# CASE 22708

APPEAL OF DRC DECISION TO HRM COUNCIL  
1325 LOWER WATER STREET, THE CUNARD BLOCK

# Variance # 3 – Tower Separation

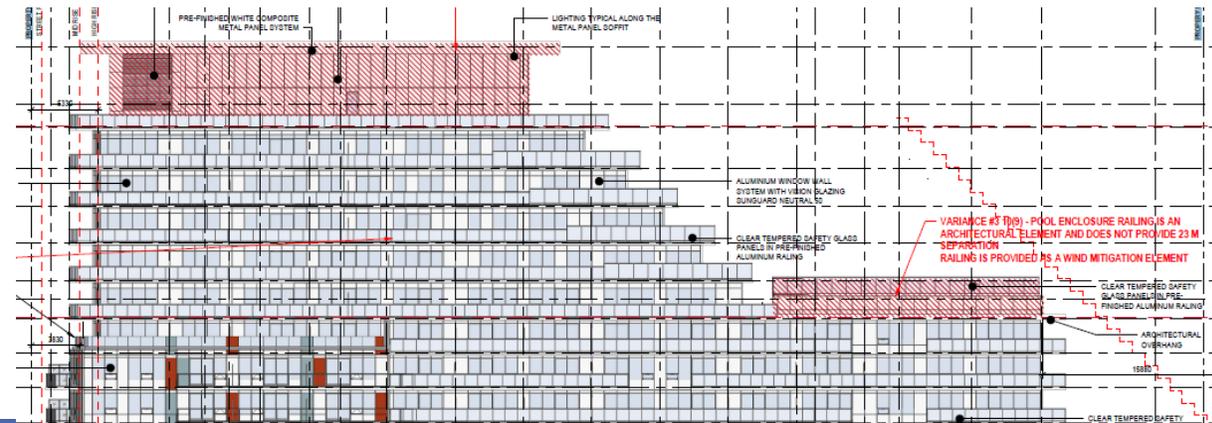
**Section 10(9)** requires that any portion of a high-rise building above a height of 33.5 m shall be separated from another non residential portion of the building by a minimum of 23 m.

3.6.7a - that the design is consistent with the objectives and guidelines of the Design Manual; and  
 3.6.7b – the modification results in a clear public benefit  
*We note that both the applicant (page 16 of the Cunard Block Downtown Land Use Bylaw Review document) and the city staff report say that this variance is required to provide wind protection for the benefit of the residents for the 12<sup>th</sup> floor amenity space (pool deck). Providing wind protection for residents is a private benefit, not a public one.*

**The only benefit is a private benefit for the users of the private pool.**

**If you agree that wind protection for pool users is not a public benefit then you (HRM council) must reject this variance**

# Variations #4 & #8 Tower Width/Depth

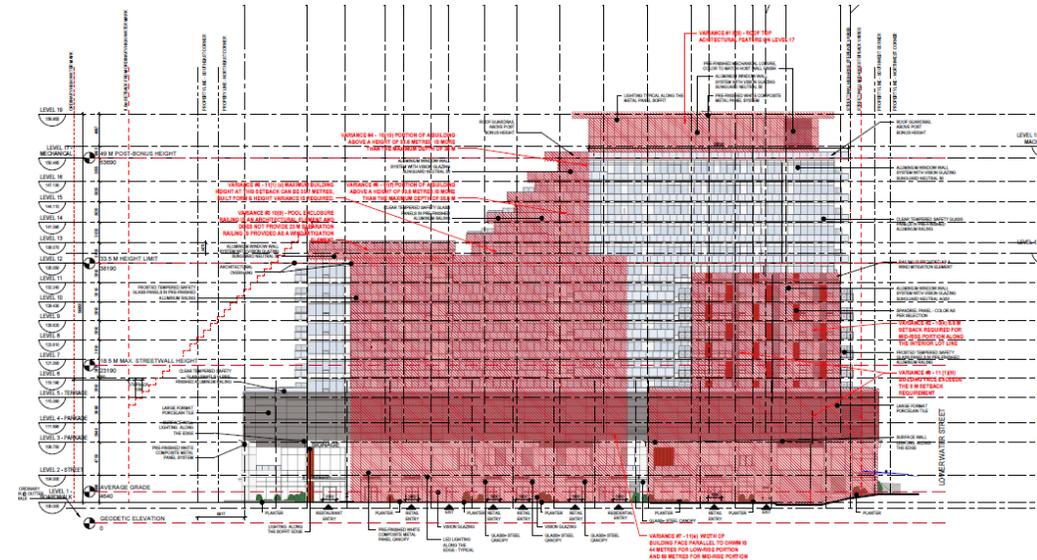
These two variations refer to the high-rise tower being both too wide and too deep. the overarching goal of the Design Manual with respect to these variations is to have tall, slender towers on the waterfront for enhanced sunlight and view planes (2.1 (c))

**Variance #4 - Section 10(10)** states that buildings shall be a maximum width of 38 m and a maximum depth of 38 m.

**Variance #8 - Section 11(1)f** requires that the maximum width of any portion of a building above a height of 33.5 m shall be 21.5 m parallel to Lower Water Street and a maximum depth of 38.5 m

The actual width of the tower is 53.4 m.

**40% wider than allowed per the Design Manual!**

# Variations #4 & #8 Tower Width/Depth

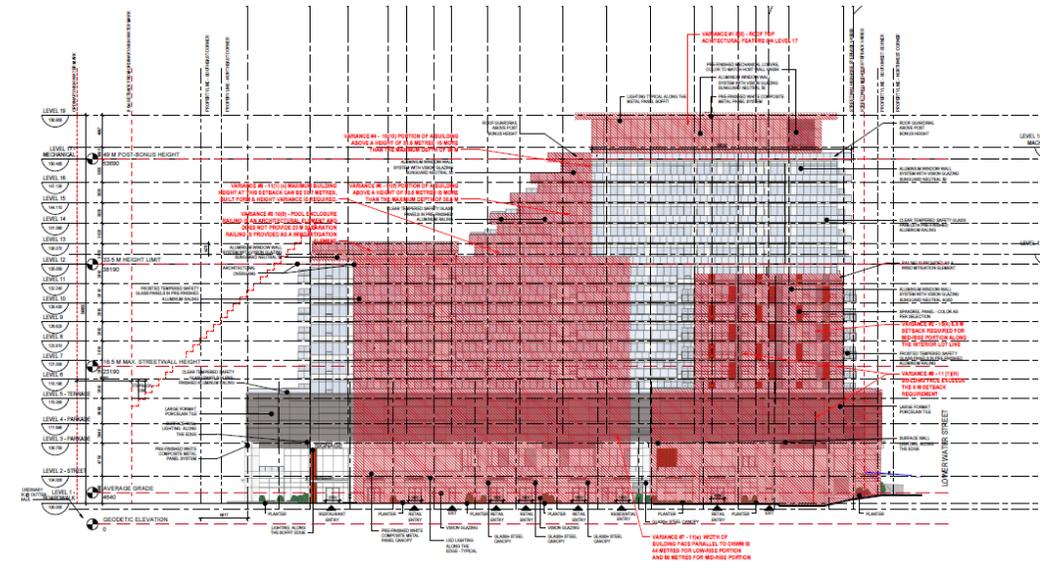
This variance was approved by the DRC on July 30, 2020 based on:

- 3.6.7a - that the design is consistent with the objectives and guidelines of Design Manual (i.e. section 2.1(c) );
- and
- 3.6.7b – the modification results in a clear public benefit

We disagree with this assessment. The wider towers encroach on sightlines and create more shade on the plaza. There is no benefit!

**Question – what exactly is the clear public benefit?**

**If you (HRM Council) do not see the public benefit then you must reject these variances!**

Variance 2 – Mid-Rise Building Section 10(4)

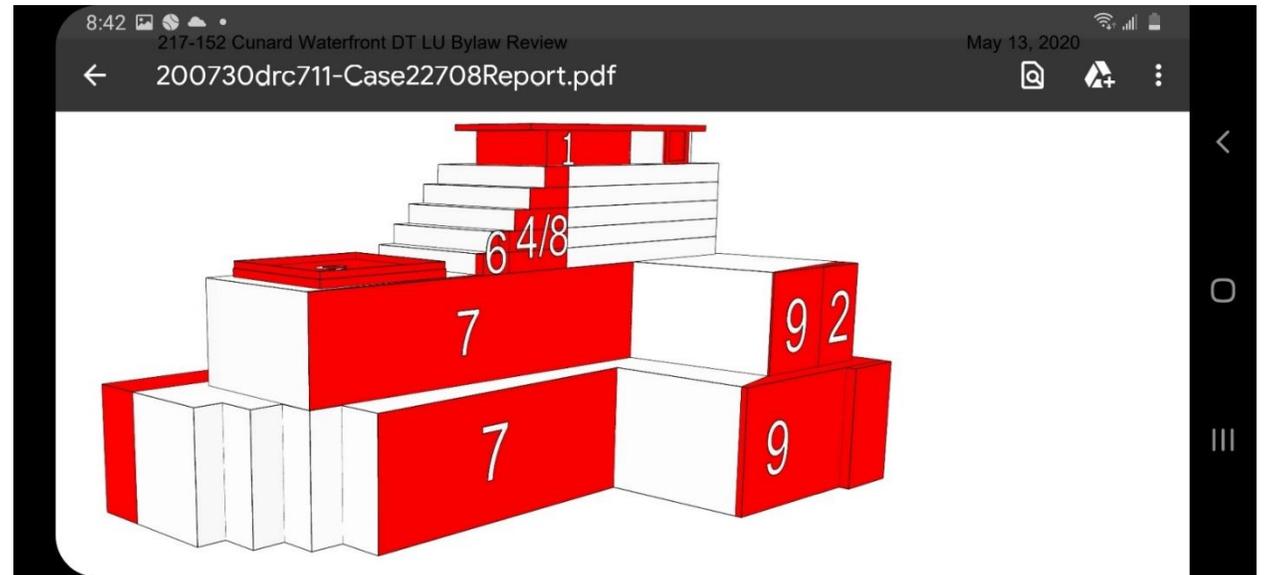
The city Center Plan Package A states

“4.2.2 WATERFRONT VIEW CORRIDORS View corridors preserve key public views of the Harbour from public streets, maintaining long-standing opportunities for pedestrians to visually connect with the water and historic resources falling within those views. Views to the Halifax Harbour waterfront will be protected in This Plan.”

Ignoring The required setbacks in order to provide Luxury accommodations for the city’s elite is not in keeping with the city center plan. I do not think the public would want to reduce their view corridors to provide profit for developers and luxury accommodations for the wealthy.

22 meters x 5.5 meters x 5 levels

Approximately 605 square meters bonus zoning

# Further Consideration (Item 2.10e)

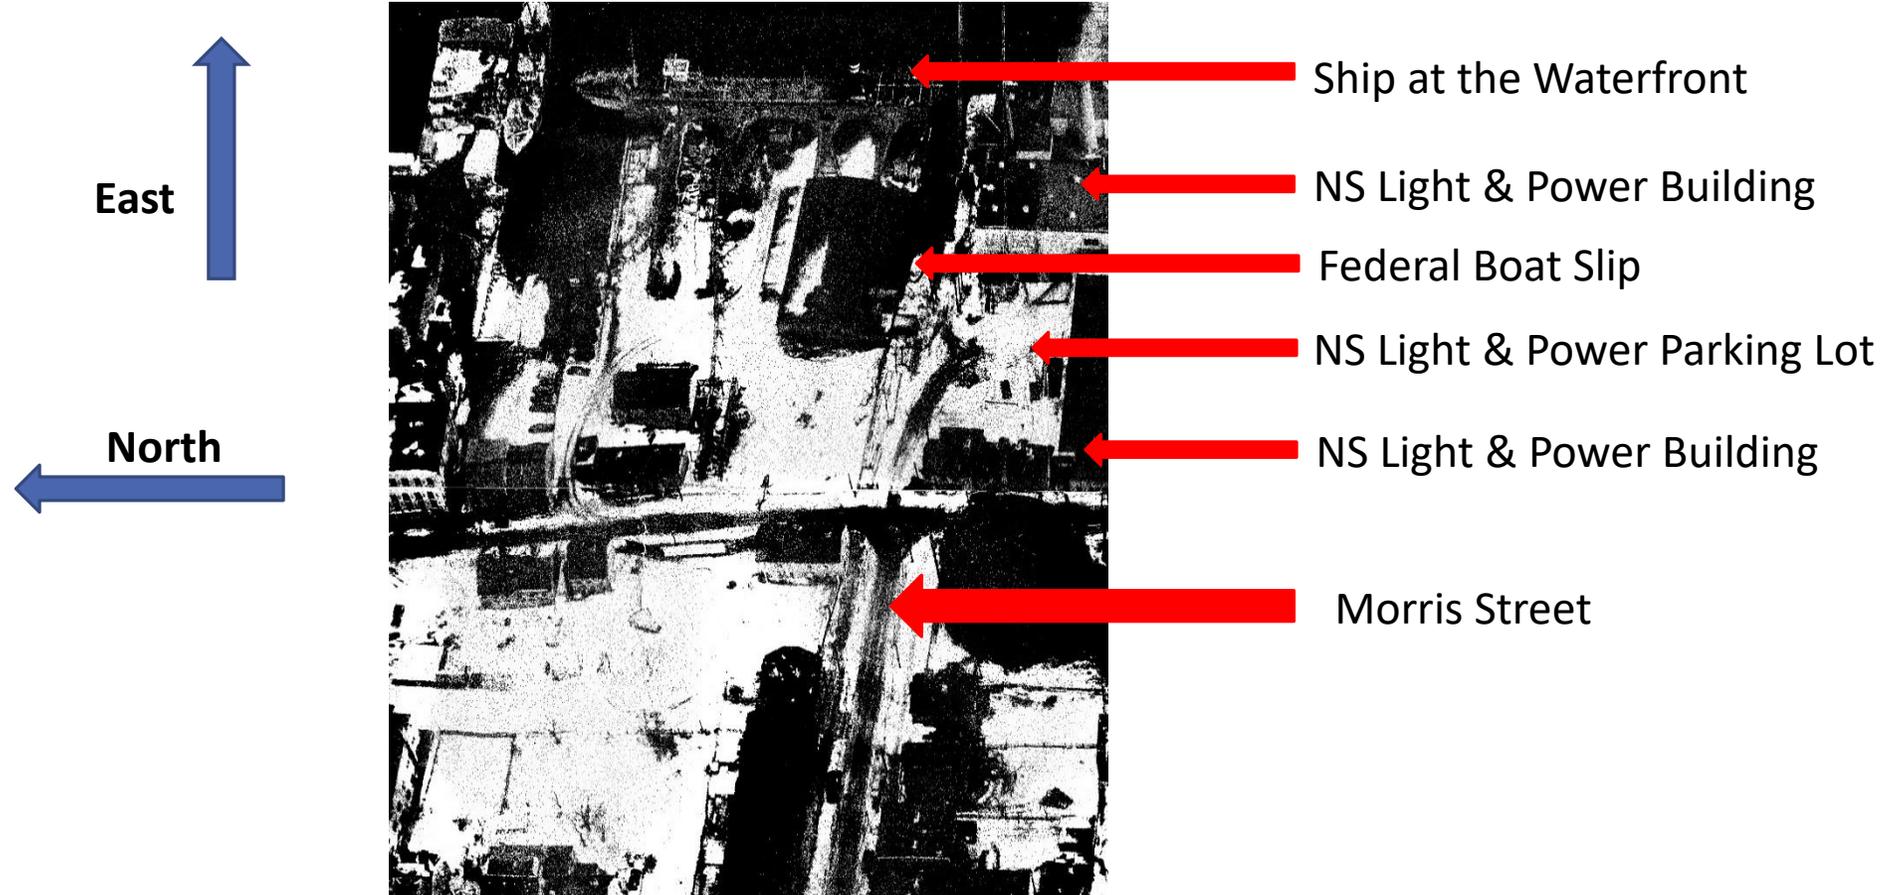
**Item 2.10e** -- “Ensure that public open spaces are provided where the eastward extension of east-west streets intersects the boardwalk. These open spaces shall be accomplished through the use of waterfront view corridors that extend from Lower Water Street to the water’s edge.”

- The intention stated at previous meetings is for the City to provide this corridor by providing land opposite Lower Water Street from Morris Street that extends down towards the waterfront.
- This land may indeed, however, be the property of Nova Scotia Power, according to historical information, such as the aerial photograph (circa 1947) on the next slide that shows clearly Morris Street leading into the parking area of what was then Nova Scotia Light and Power Corporation.
- This would invalidate the city’s intention to provide this land.
- This would also prevent parking access and garbage pickup along the Morris St. extension.
- **Request:** Please provide evidence that the City actually owns the so-called Morris Street extension lands.

# Open Space

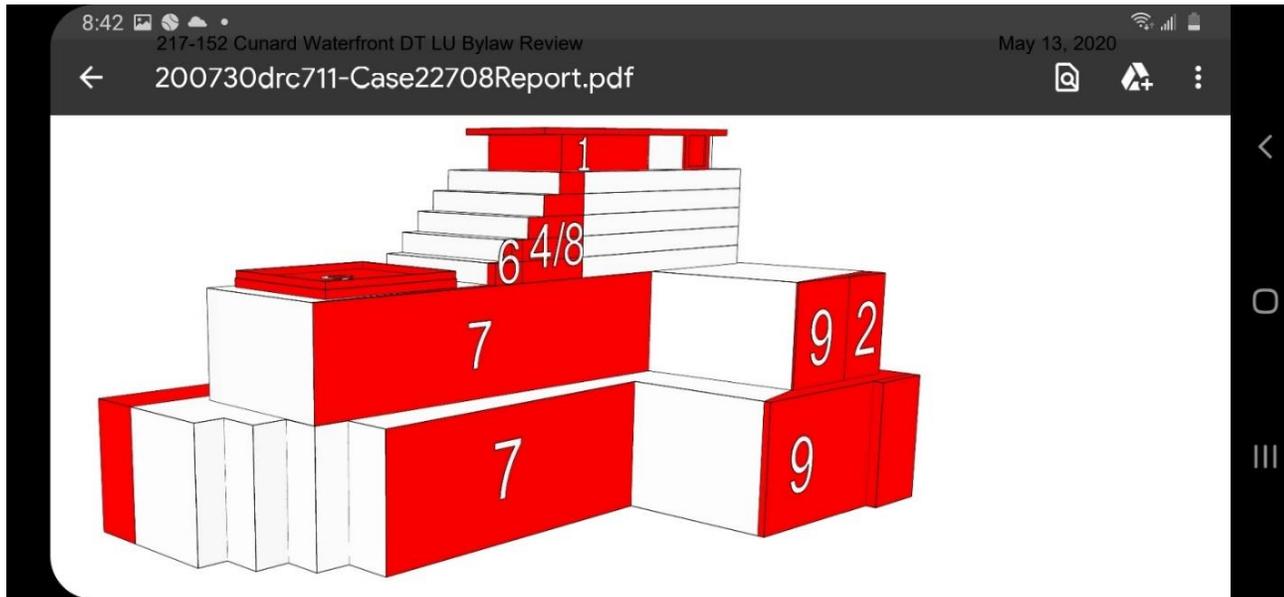
Variance 9 - Southern Waterfront Section 11(1)(h) Buildings on lots with a streetline width greater than 27.5 metres shall be setback from interior lot lines no less than 10% of the lot width or 8 metres, whichever is less. Where a lot has more than one streetline, the greater lot width shall apply; and clauses (b) through (e) apply to any building or portion thereof within 30 metres of the ordinary high-water mark.

The proposed Cunard Lot Development does not appear to be designed for any of these uses and only houses a few bike racks.

# Issues re: Public Space

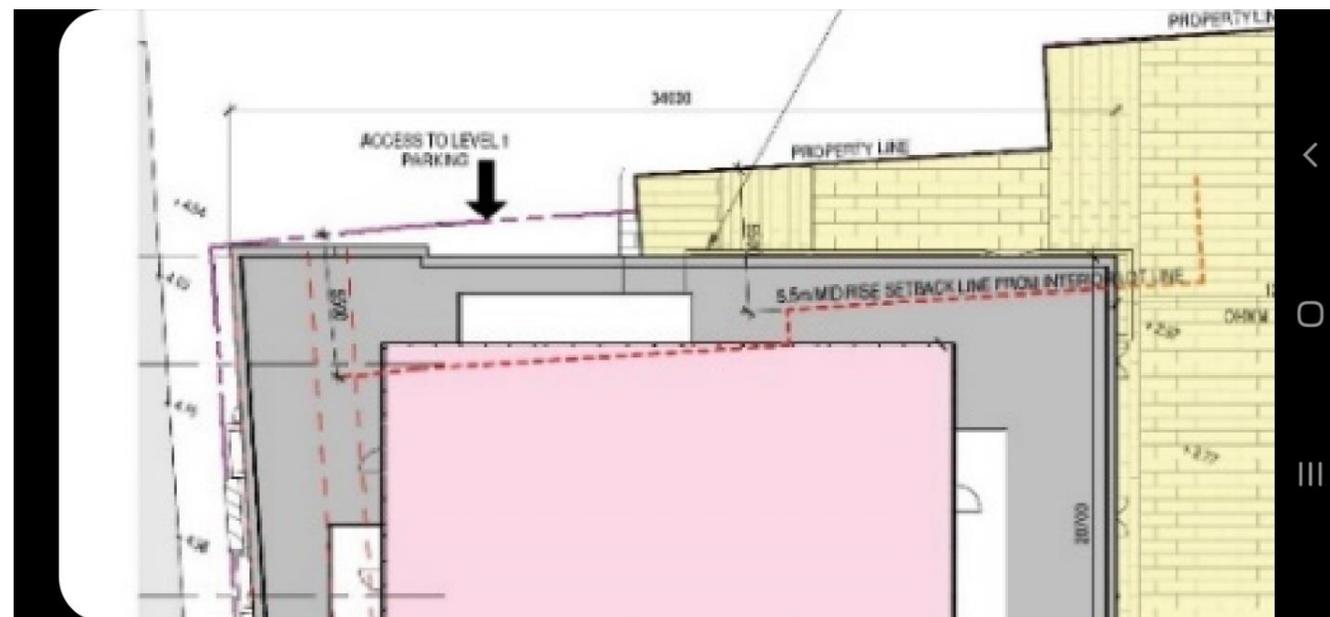
You can see in this slide the building hugs the property line restricting access to the open space.

The design does not Create a system of open space that includes: - extensions of east-west streets between Lower Water Street and the Harbour as key components of an open space network; - the boardwalk; - sidewalks along Lower Water Street, and; - plazas and small parks where the extensions of the east-west streets intersect the boardwalk. The L shape of the building prevents visual and physical access from Lower Water Street to the waterfront as the building is massed out to the property boundaries along Lower Water Street due to variance #9 Southern Waterfront Section 11(1)(h) Buildings on lots with a streetline width greater than 27.5 metres shall be setback from interior lot lines no less than 10% of the lot width or 8 metres, whichever is less. Where a lot has more than one streetline, the greater lot width shall apply; and clauses (b) through (e) apply to any building or portion thereof within 30 metres of the ordinary high-water mark.

## Excerpt from: Cunard Waterfront DT LU Bylaw Review

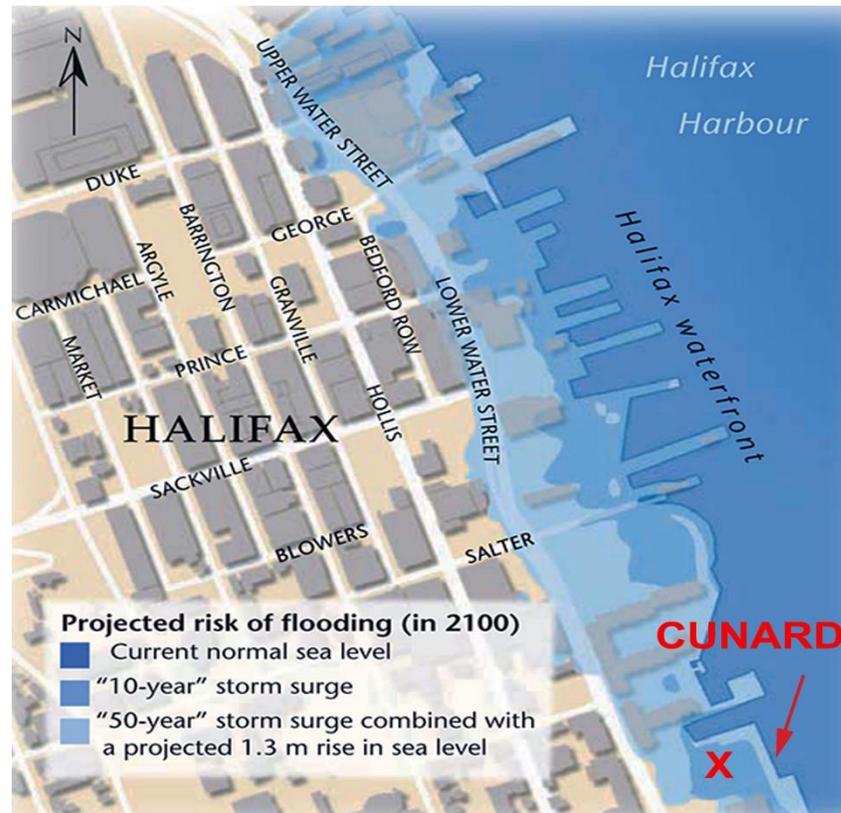
(12) No residential portion of a building on a lot within Schedule W, shall be erected, constructed at an elevation less than **3.8 metres** of the Canadian Geodetic Vertical Datum. First finished residential level of Cunard building is established at +7.12m CGVD. Greenland Icesheet melt adds + 6 m without additional storm parameters (+5.5 m)

The model shows  
 1) 3.2m setup used in Cunard plan versus  
 2) potential worst-case flood at a storm tide when Greenland melts

**IN CONCLUSION, WE ASK “ WAS THE CORRECT VALUE OF 3.8m REQUIRED BY COASTAL PROTECTION ACT USED TO DESIGN A SAFE CUNARD? OR WAS A LESSER VALUE USED?”**
